Access Compliance Report

Public Rights-of-Way

Intersection ID: 2895	Main Street: CREEK_BREEZE_RD	Cross Street: RIDGE_RD	Location: W
ADA ID: 8EA038F347A4	Ramp Type: Perpendicular Diagonal	Initial Pass/Fail: Fail	Overall Compliance: No
			Severity Score: 46.25

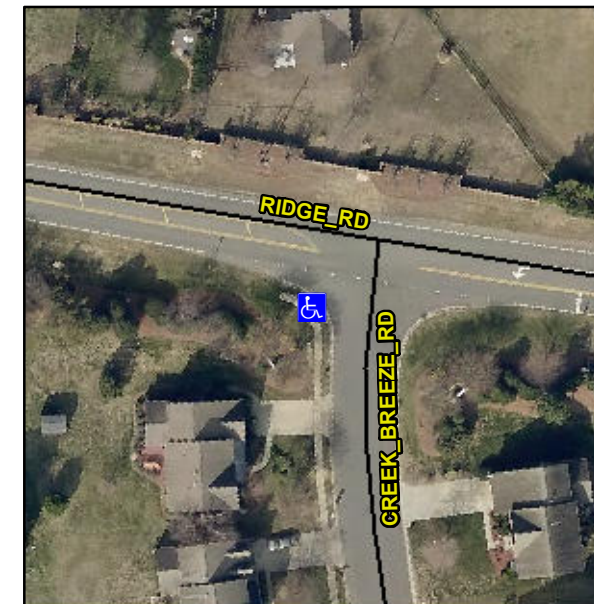
R304.5.1, R304.2.2, R304.5.3

Compliance	Description	Data	Compliance	Description	Data
N/A	Ramp Length (in)	46.0	No	Ramp Slope (%)	13.4
No	Ramp Width (in)	44.0	No	Ramp XSlope (%)	6.6
N/A	Flare Type LT	N/A	N/A	Flare Type RT	N/A
N/A	Flare Slope LT (%)	N/A	N/A	Flare Slope RT (%)	N/A
N/A	Flare Traversable LT?	N/A	N/A	Flare Traversable RT?	N/A
N/A	Landing Length (in)	N/A	N/A	DWS Provided?	N/A
N/A	Landing Width (in)	N/A	N/A	DWS Contrast?	N/A
N/A	Landing Slope (%)	N/A	N/A	DWS Length (in)	N/A
N/A	Landing X Slope (%)	N/A	N/A	DWS Full Width?	N/A
N/A	Landing Curb? (Y/N)	N/A	N/A	DWS Offset (in)	N/A
N/A	Shared Landing?	N/A			
N/A	Gutter Ponding?	N/A	N/A	Gutter Slope (%)	N/A
N/A	Gutter Lip Ht (in)	N/A	N/A	Gutter X Slope (%)	N/A
N/A	Painted X Walk1?	No	N/A	Painted X Walk2?	No
	X Walk 1 Direction	To SE		X Walk 2 Direction	To NE
N/A	X Walk 1 Width (in)	N/A	N/A	X Walk 2 Width (in)	N/A
	X Walk 1 Slope (%)	1.5		X Walk 2 Slope (%)	7.8
	X Walk 1 X Slope (%)	8.4		X Walk 2 X Slope (%)	1.4

Remove & Replace Curb Ramp With Two New Directional Ramps or Equivalent.
